## **Revision to the Design and Operations Report – Jericho Wind Energy Centre**

AECOM

60301207

September, 2013

Figure 2-1

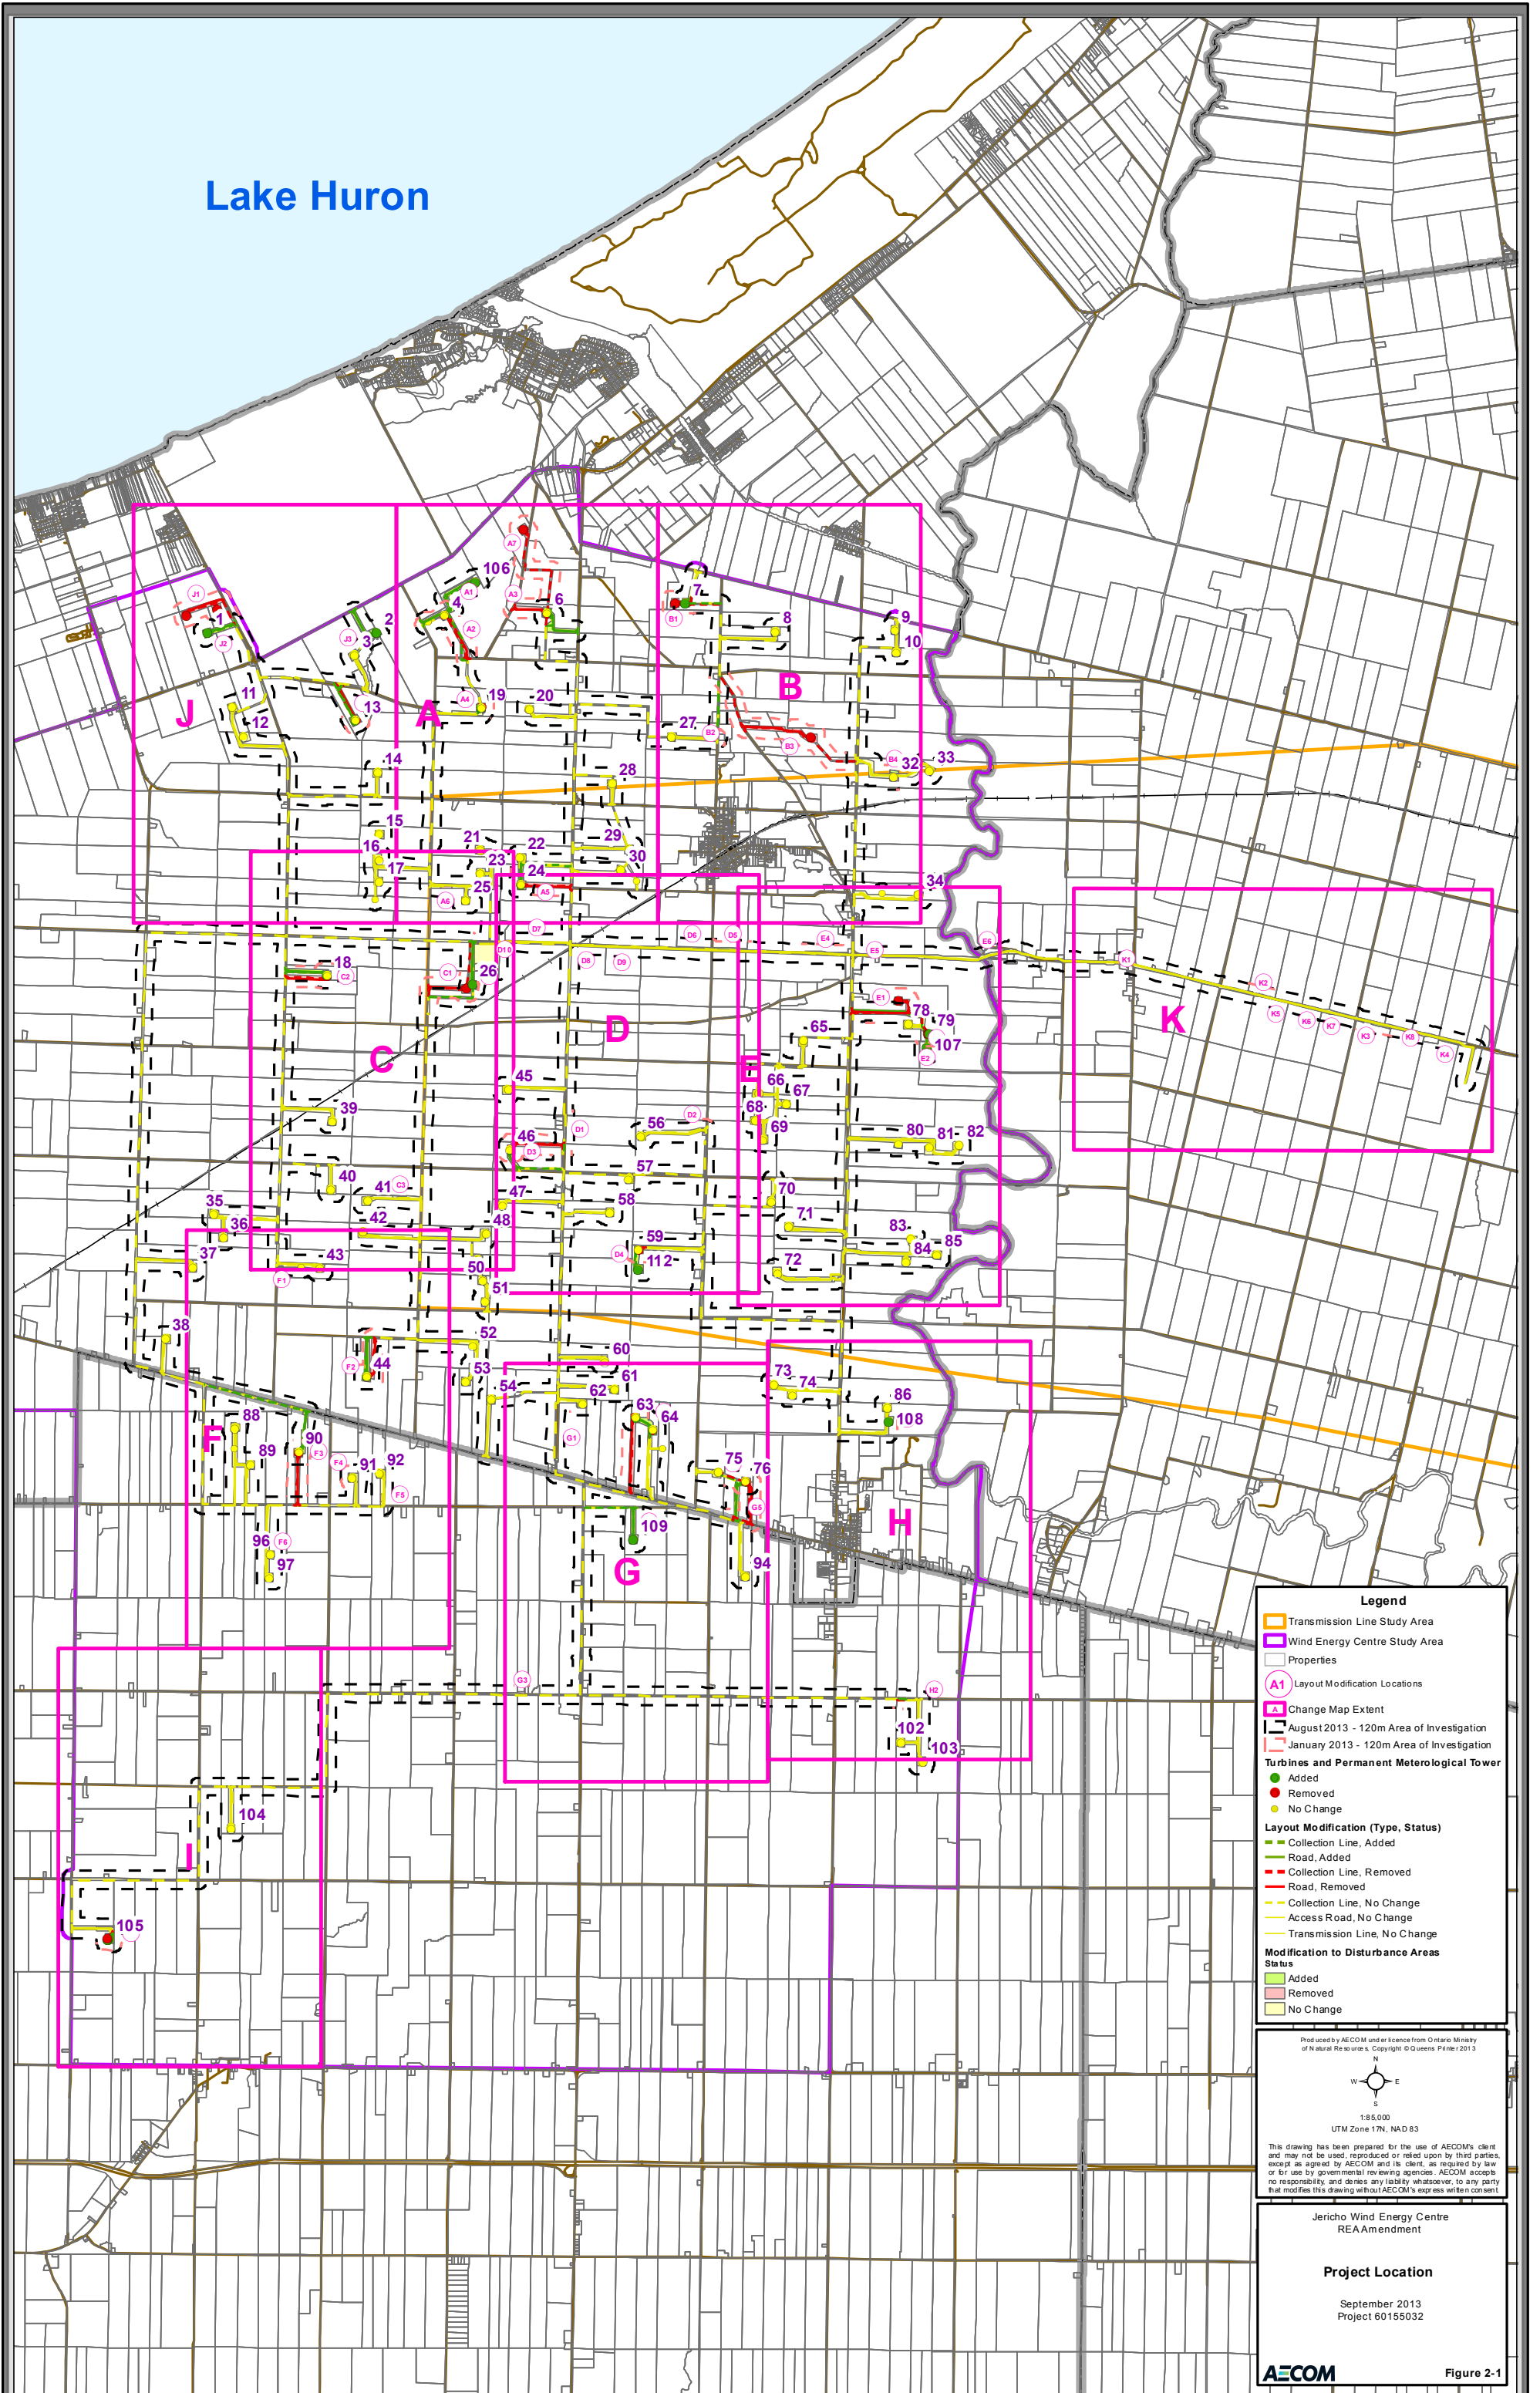
**Figure 2-1** illustrates the modified Project Location. **Appendix A** contains a series of figures showing the details for each of the modifications.

Label on Figure 2-1	Proposed Modification	Rationale for Proposed Modification	New Potential Environmental Effects	New Mitigation Measures (Mitigation measures not included in the original REA are shown in <i>italicized bold</i> )
A1	Addition of Turbine 106 and associated access road and collection line, extending north east from Turbine 4.	Infrastructure or construction disturbance area added or changed to optimize project design/ constructability.	<p><u>Natural Heritage:</u></p> <ul style="list-style-type: none"> <li>Access road is 24 m from a new Rare Vegetation Community Feature RVC-05 not previously described in the NHA. There are no potential effects to this feature associated with the access road during operation.</li> <li>Access road and collection line are within 120 m of new Generalized Candidate Significant Wildlife Habitat Feature (Insect Species of Conservation Concern Habitat, Plant Species of Conservation Concern Habitat, and Red-headed Woodpecker Habitat) in Natural Area 290, not previously described in the NHA. There are no potential effects on this feature associated with the access road and collection line during operation.</li> </ul> <p><u>Water Bodies:</u></p> <ul style="list-style-type: none"> <li>Effects associated with new crossing of a water body (Feature ID R4.16-D) include: <ul style="list-style-type: none"> <li>Increase in impervious surfaces from presence of turbine foundation and access roads, resulting in increased water temperatures, increased surface runoff and stream peak flows, and reduced infiltration, base flows and upwelling.</li> <li>Soil/water contamination by oils, grease and other materials from accidental spills and release of contaminants from equipment.</li> <li>Obstruction of lateral flows in watercourses and other water bodies due to design of culverts and debris build-up at water crossings.</li> </ul> </li> </ul>	<p><u>Natural Heritage:</u></p> <ul style="list-style-type: none"> <li>N/A</li> </ul> <p><u>Water Bodies:</u></p> <ul style="list-style-type: none"> <li>Regularly maintain vehicles and other equipment.</li> <li>Minimize vehicle traffic on exposed soils and sensitive slopes.</li> <li>Locate facilities where contaminants are handled at least 30 m away from water bodies.</li> <li>Develop and implement an erosion and sediment control plan.</li> <li>Develop a spill response plan.</li> <li>Control soil / water contamination through best management practices.</li> <li>Design culverts to accommodate high flows of the watercourse.</li> <li>Inspect culverts during routine maintenance activities for buildup of debris.</li> </ul>

A2	Relocation of access road to Turbine 4 to travel north east from Jericho Road, and relocation of collection line to Turbine 4 near Kennedy Line.	Construction disturbance area modified to reduce or eliminate impacts to archaeological resources.	None – no new natural heritage or water body features within 120 m; area previously studied for cultural heritage.	N/A
A3	Relocation of access road and collection line to Turbine 6 to travel west from Northville Road and then north to Turbine 6; relocation of Turbine 6 construction disturbance area to the north.	Construction disturbance area modified to reduce or eliminate impacts to archaeological resources.	None – no new natural heritage or water body features within 120 m; area previously studied for cultural heritage.	N/A
A4	Relocation of Turbine 19 construction disturbance area 19 m to the southwest and addition of access road construction disturbance area near Jericho Road.	Construction disturbance area modified to reduce or eliminate impacts to archaeological resources.	None – no new natural heritage or water body features within 120 m; area previously studied for cultural heritage.	N/A

A5	Removal of access road and collection line to Turbine 24, addition of access road disturbance area between Turbine 22 and Turbine 24 and relocation of collection line to the access road disturbance area for Turbine 22.	Infrastructure or construction disturbance area added or changed to optimize project design/ constructability.	None – no new natural heritage or water body features within 120 m; area previously studied for cultural heritage.	N/A
A6	Removal of a portion of construction disturbance area for access road and collection line to Turbines 21, 23 and 25.	Construction disturbance area modified to reduce or eliminate impacts to archaeological resources.	None – no new natural heritage or water body features within 120 m; area previously studied for cultural heritage.	N/A
A7	Removal of Turbine 5 and associated access road and collection line.	Turbine and associated infrastructure removed.	None – no new natural heritage or water body features within 120 m; area previously studied for cultural heritage.	N/A

B1	Relocation of Turbine 7 and associated construction disturbance area 148 m to the east.	Infrastructure or construction disturbance area added or changed to optimize project design/ constructability.	None – no new natural heritage or water body features within 120 m; area previously studied for cultural heritage.	N/A
B2	Addition of collection line in Gordon Road right-of-way, north of the road to Turbine 27.	Infrastructure or construction disturbance area added or changed to optimize project design/ constructability.	<p><u>Natural Heritage:</u></p> <ul style="list-style-type: none"> <li>Collection line is within 120 m of new Generalized Candidate Significant Wildlife Habitat Feature (Plant Species of Conservation Concern Habitat and Red-headed Woodpecker Habitat) in Natural Area 233, not previously described in the NHA. There are no potential effects on this feature associated with the collection line during operation.</li> </ul>	<p><u>Natural Heritage:</u></p> <ul style="list-style-type: none"> <li>N/A</li> </ul>

B3	Removal of Turbine 31 and associated access road and collection line.	Turbine and associated infrastructure removed.	<p><u>Natural Heritage:</u></p> <ul style="list-style-type: none"> <li>Amphibian Woodland Breeding Habitat Feature AWO-16 in Natural Area 250 was changed to Generalized Candidate Significant Wildlife Habitat because it is more than 120 m away from a proposed access road. There are no potential effects on this feature associated with operation of the project.</li> </ul>	N/A
B4	Addition of Turbine 32 construction disturbance area 34 m to the north and removal of the southeast portion of construction disturbance area.	Construction disturbance area modified to reduce or eliminate impacts to archaeological resources.	None – no new natural heritage or water body features within 120 m; area previously studied for cultural heritage.	N/A
